Project
**East West Rail
(Western Section)
Phase 2**

Drawing Title
**PASSING PLACE A3_P_6
GENERAL ARRANGEMENT**

Stage 2 Road safety audit response report

Offline Highways Passing Places – Package 2 – Oxfordshire (A3 Marsh Gibbon – Compound Access)

PASSING PLACE A3_P_6 EXISTING UTILITIES AND SITE CLEARANCE

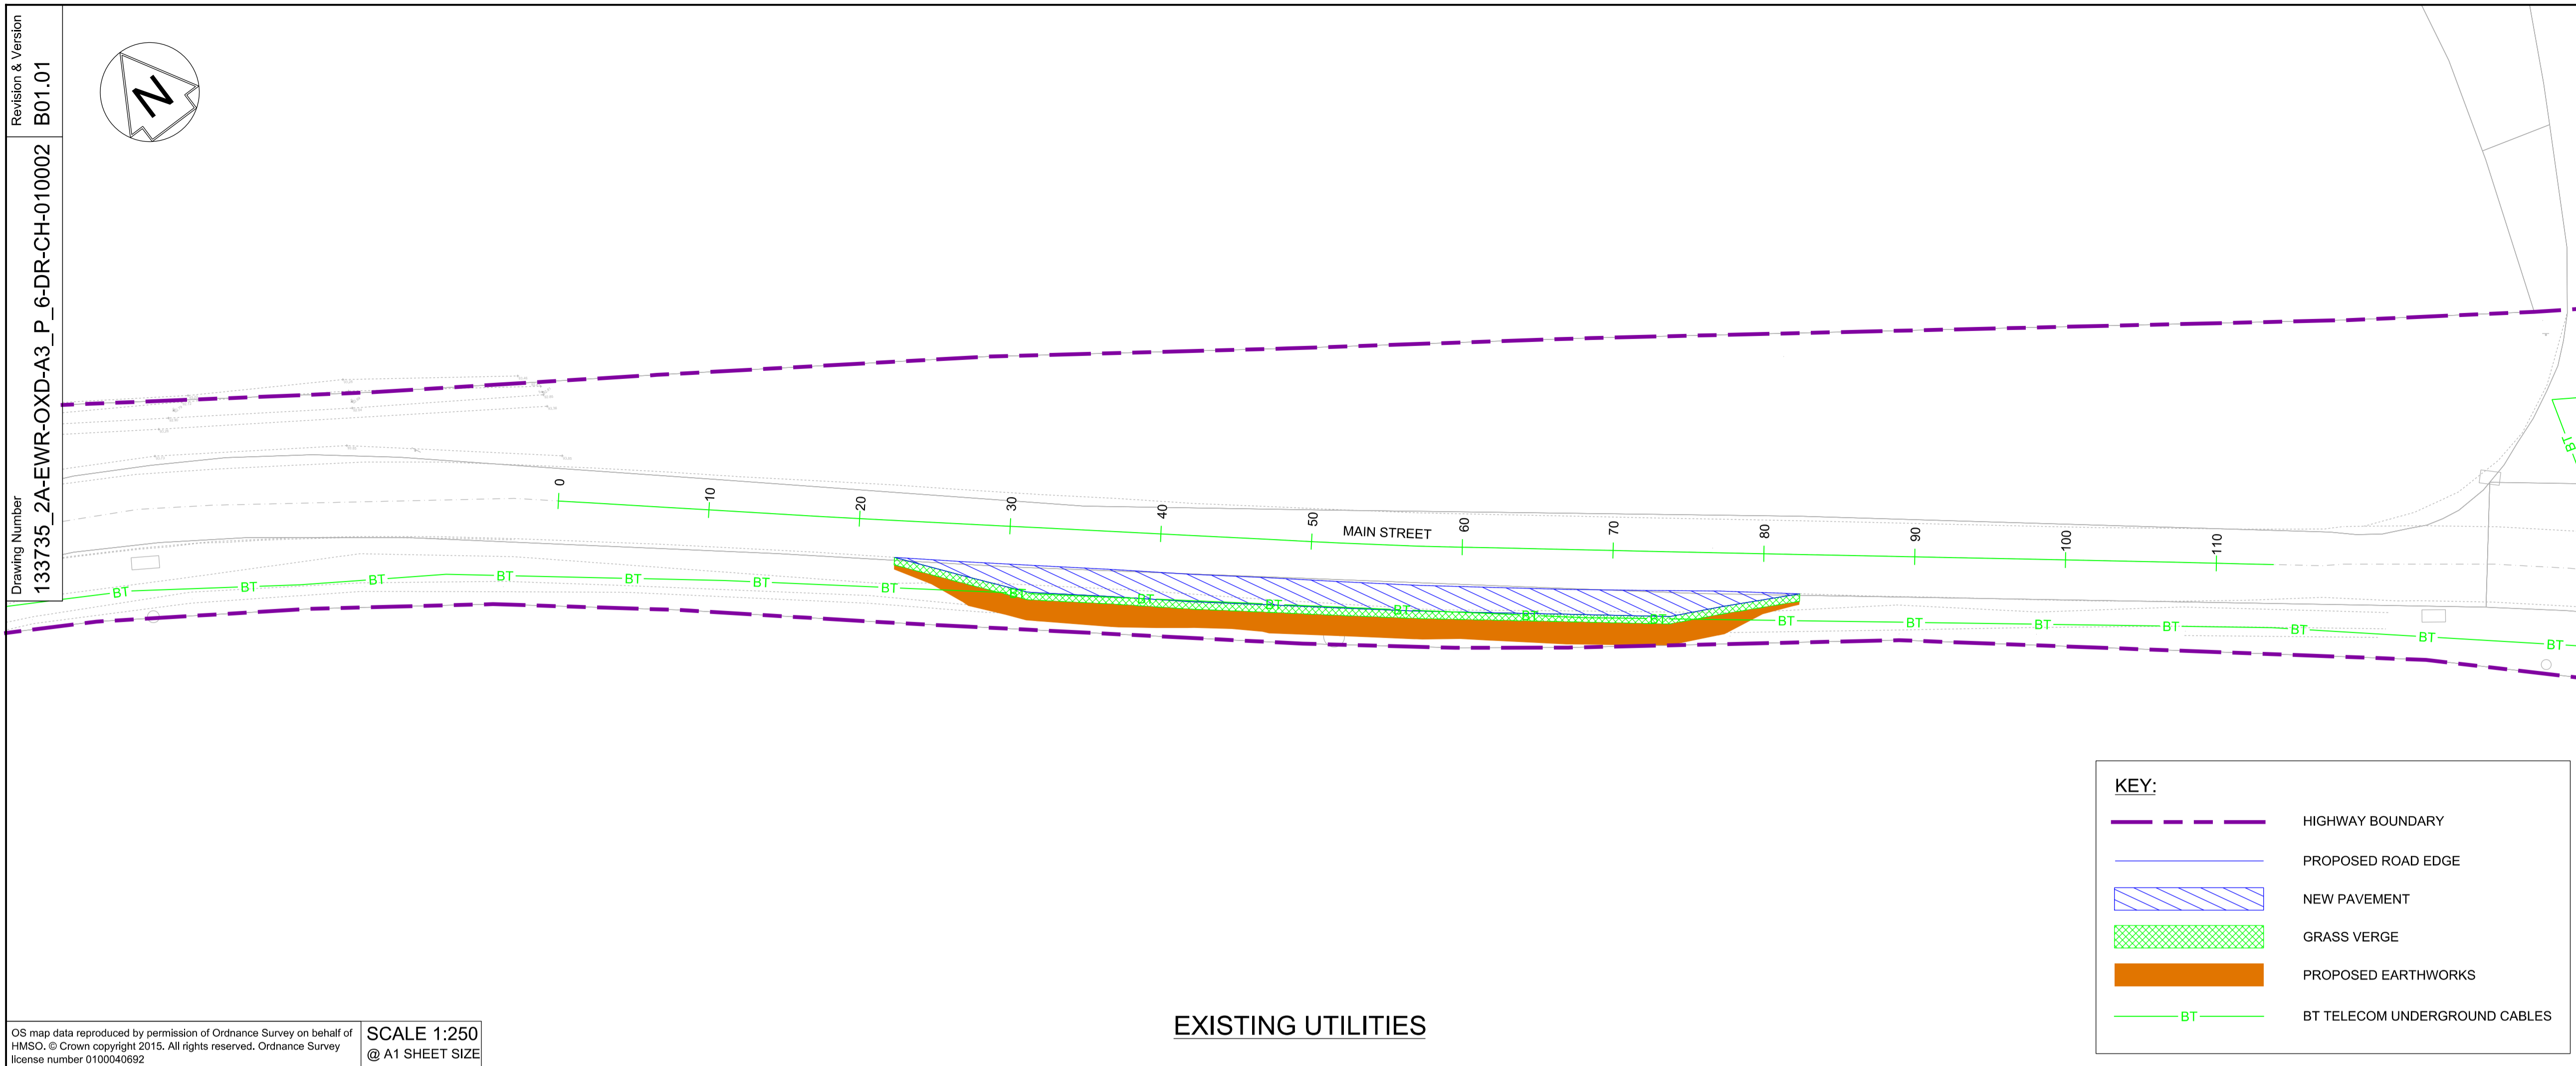
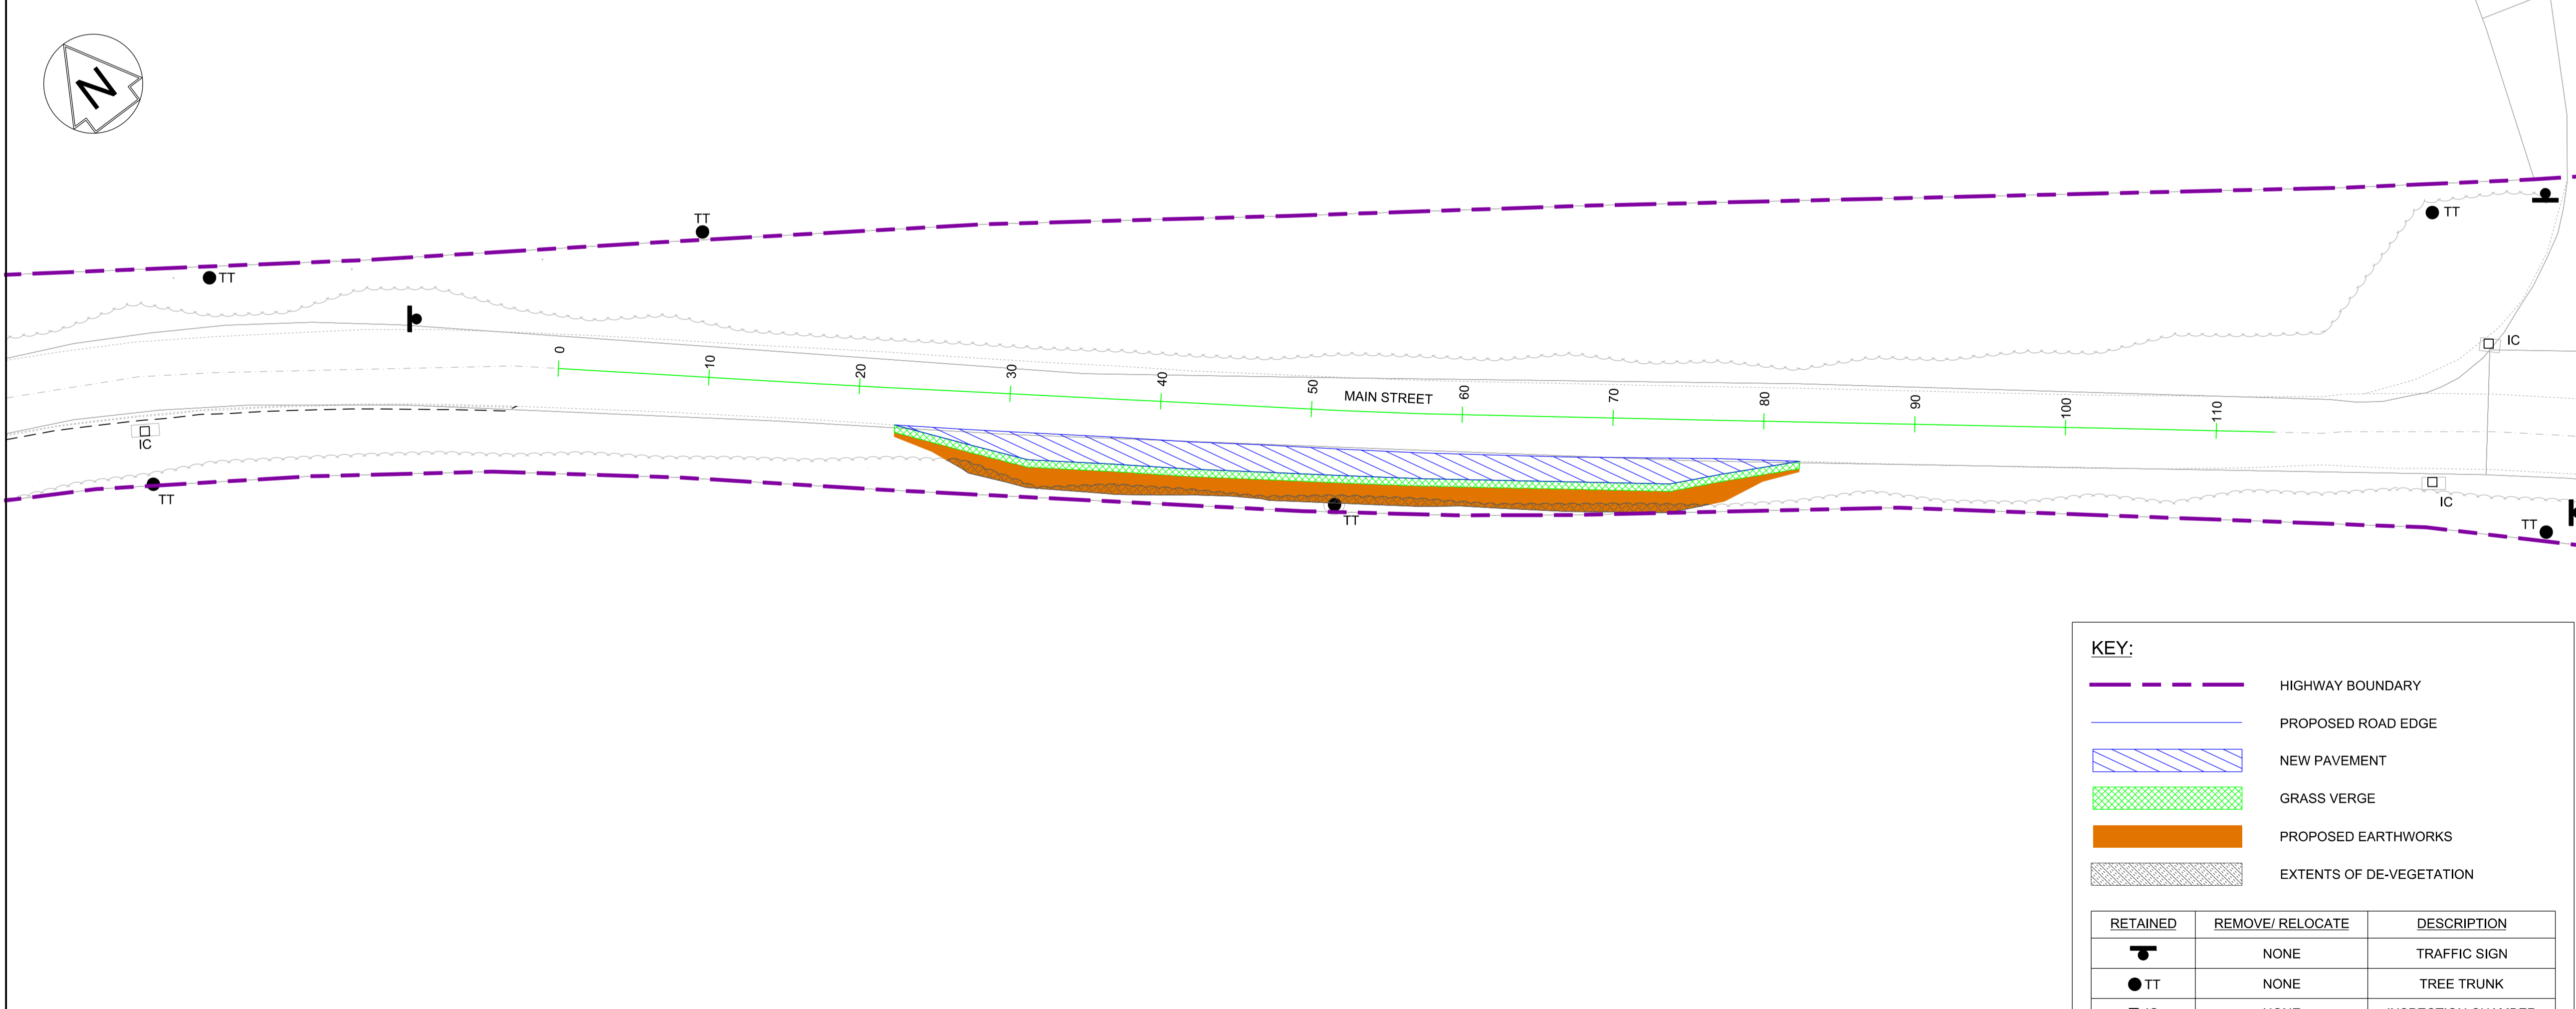
Driver accessibility to passing places is obstructed by trees, and in some locations, signposts situated in the verge. There is a risk that drivers may collide with the trees on entry/exit of the passing place. Also, drivers' forward visibility is restricted by the location of these trees and as such, drivers of construction vehicles may not be aware that they should wait and might proceed, increasing the risk of side swipe collisions. Additionally, approaching drivers may not anticipate the construction vehicle leaving the passing place, leading to side swipe or head on collisions.

RSA Ref	Location	RSA Problem	RSA Recommendation	Design Team Response	Network Rail Response	Agreed RSA action
2.1	Passing Places A3-P-1, A2-P-1, A3-P-2 and A3-P-8. Unnamed Road (towards Mill Road).	Obstructions in verge increase risk of collision Driver accessibility to passing places is obstructed by trees, and in some locations, signposts situated in the verge. There is a risk that drivers may collide with the trees on entry/exit of the passing place. Also, drivers' forward visibility is restricted by the location of these trees and as such, drivers of construction vehicles may not be aware that they should wait and might proceed, increasing the risk of side swipe collisions. Additionally, approaching drivers may not anticipate the construction vehicle leaving the passing place, leading to side swipe or head on collisions.	Obstructions should be removed from the verges.	Accept the RSA problem and recommendation made by the RSA team. The site clearance drawings note that vegetation clearance shall be undertaken to provide suitable visibility. There is also a note for the lifting of tree crowns to provide 5m clearance above ground level to the back of the proposed verge.	Accepted	Proceed as Design Team Response
